Planning Board Agenda

Public hearing on application for Subdivision Approval, 2 residential lots, Monell Place, submitted by Allison Cross & Henry Nye

On behalf of the co-Applicants, Allison Cross and Henry Nye, Hudson Land Design (HLD) has revised the plans in response to Lanc & Tully's February 4, 2021 comment letter, and John Clarke Planning and Design's February 4, 2021 comment memorandum. Below is a point-by-point response to the comments received.

To: John Gunn, Chair, and the City of Beacon Planning Board
Date: April 8, 2021
Re: **Monell Place Subdivision**

SUBDIVISION PLAN

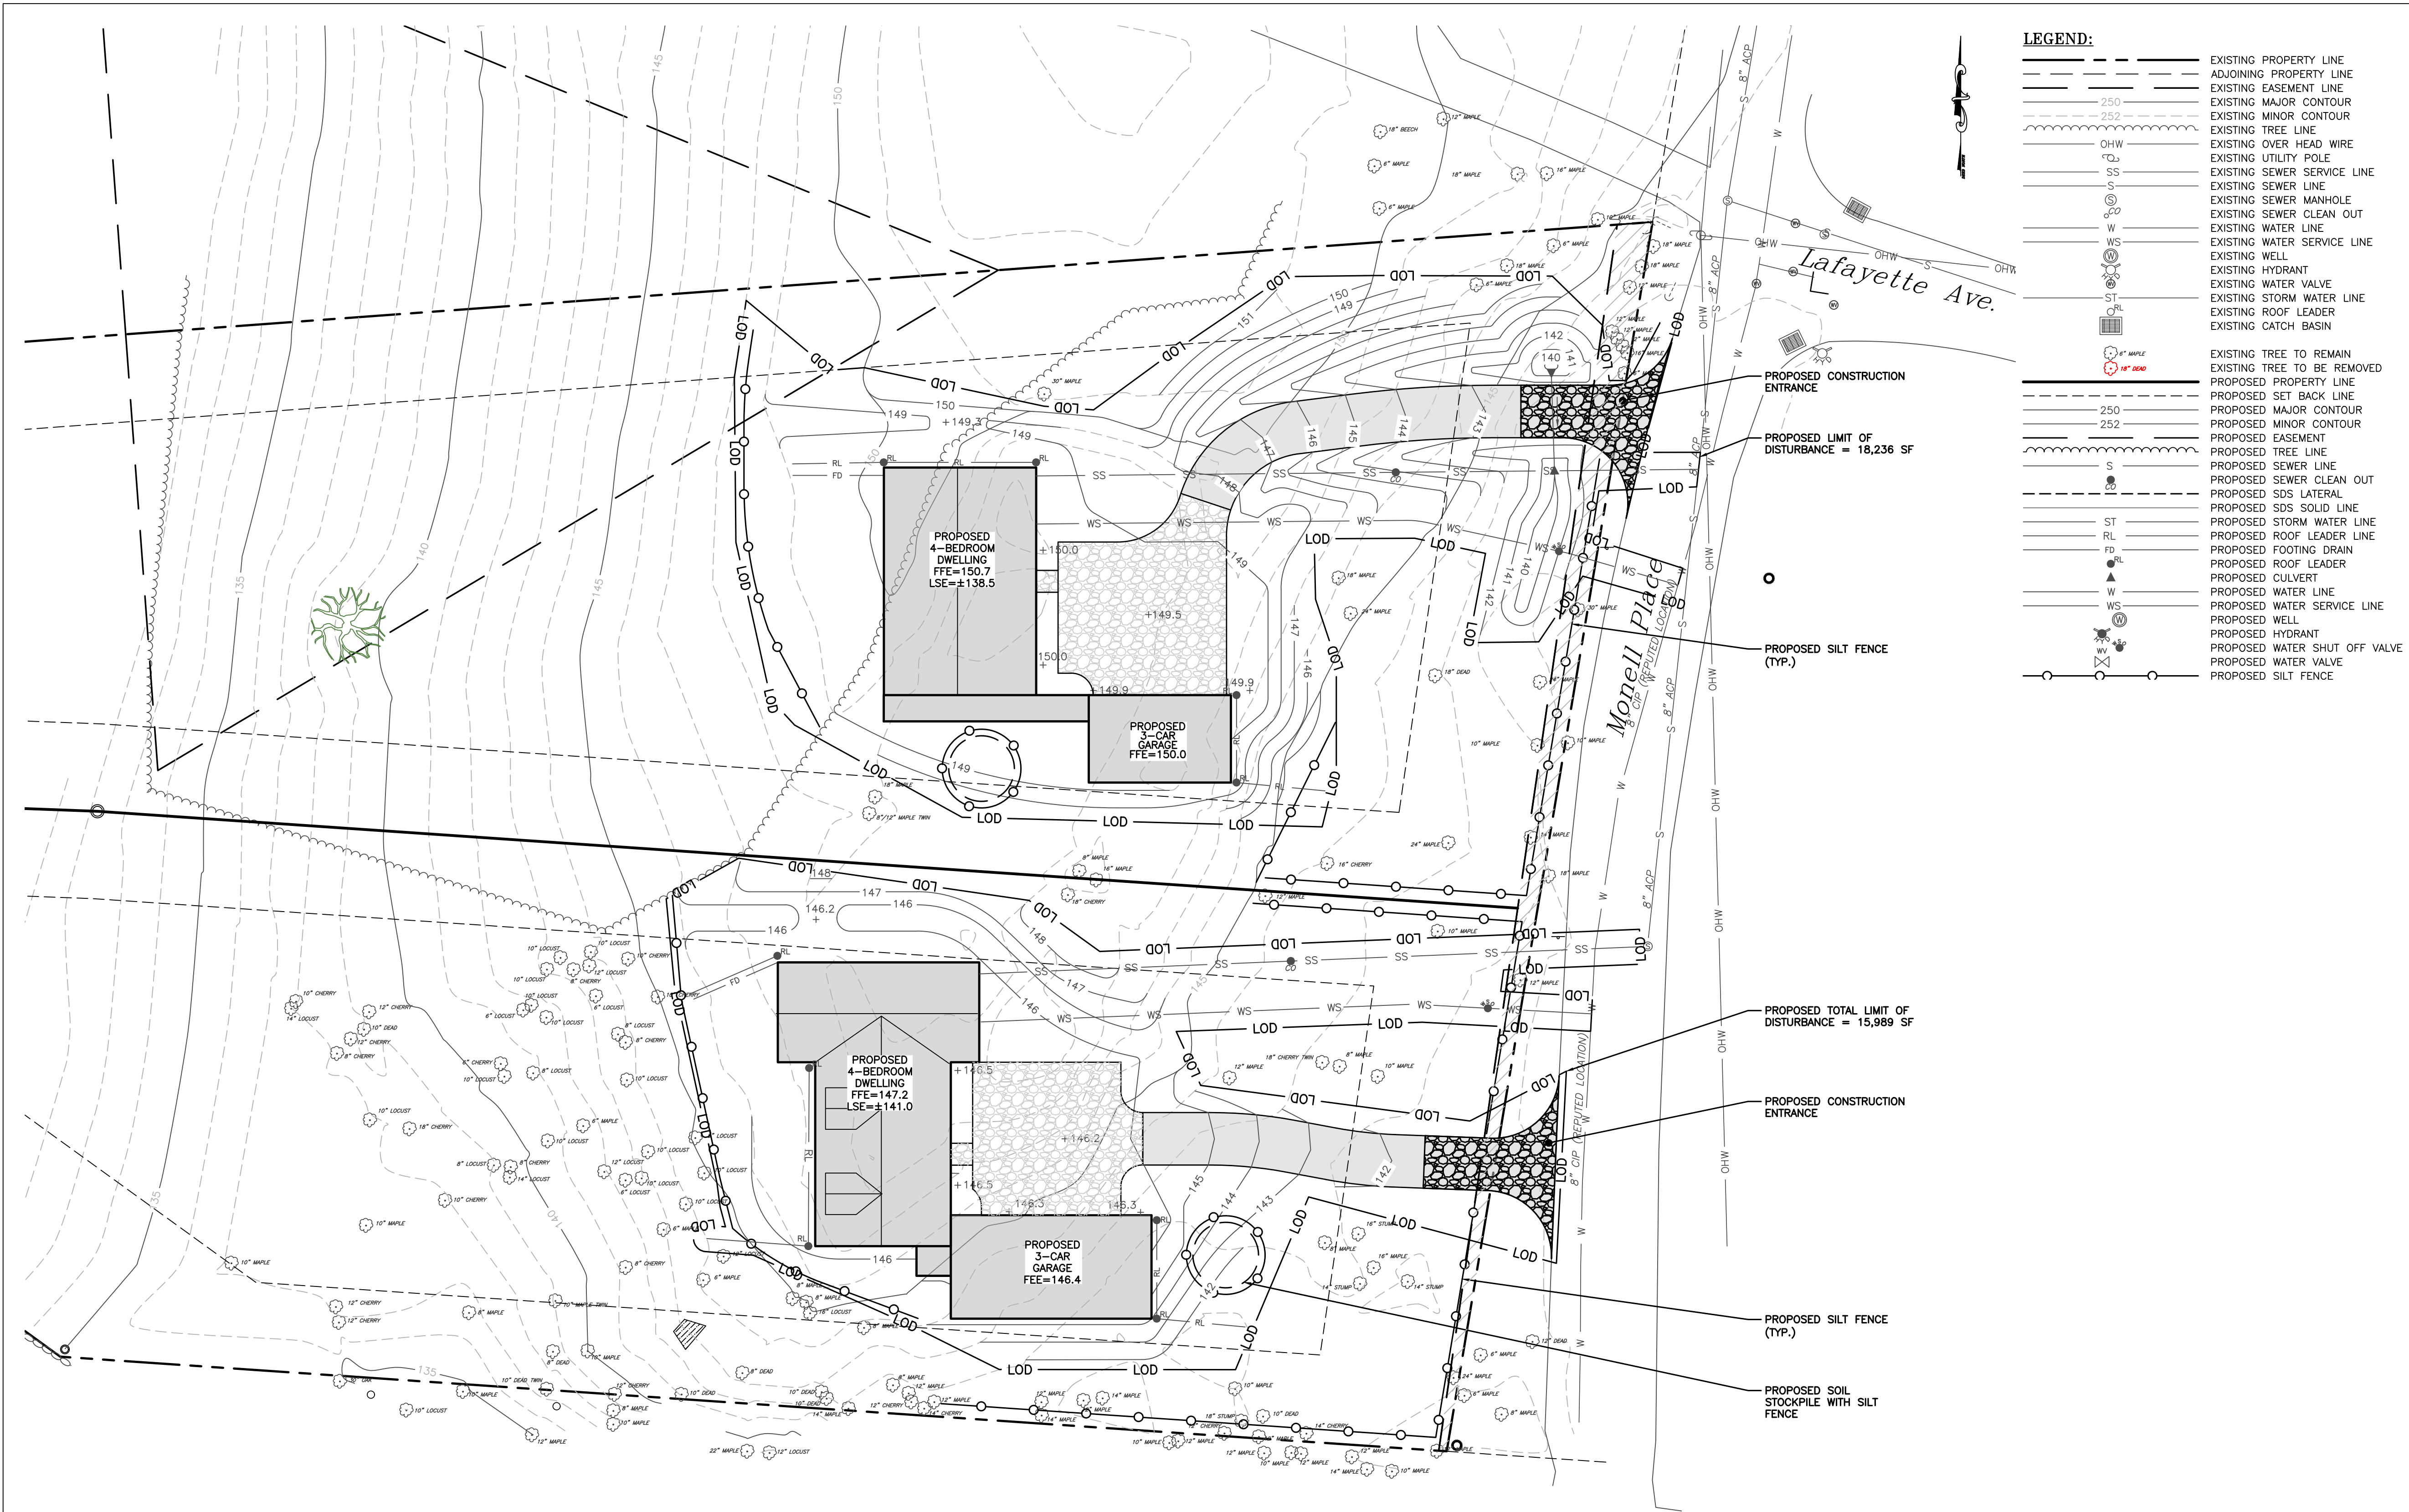
1. The plans will be updated once the manhole is uncovered and raised to grade.
2. The 12" HDPE has been lowered and the inlet and outlet regraded to accommodate the lower elevation of the pipe.
3. The proposed grading has been adjusted to direct stormwater away from the proposed dwellings.
4. The existing water line has been verified to be 6" in size with the water department.
5. The static pressure will be measured and provided for review now that warmer weather is upon us. Based upon recent pressure readings from other projects in the area, it is expected that the static pressure will be around 80 psi.
